Notification

Update of Airspeed Indicator and POH

Release Number: NOT-014-ASI update

Models affected: GX, certified as LSA

3.1 Installation of static port compensation sheets:

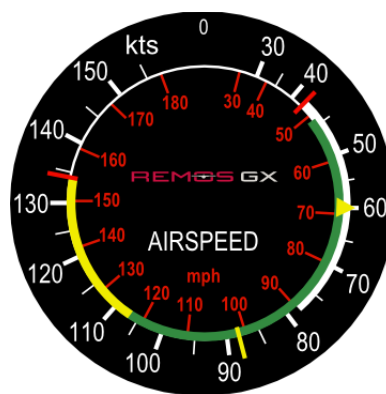
- clean the area at least 2 inches (50mm) around both static ports
- apply some adhesive, e.g. Henkel TEROSON MS9380 or equivalent on the backside of the sheets
- stick the sheets behind the static ports so that the round cutout matches with the static port
- achieve a gluing gap between fuselage and compensation sheet of not more than 0.5mm
- the rear protruding part of the sheet shall be vertical with the aircraft standing level on its wheels
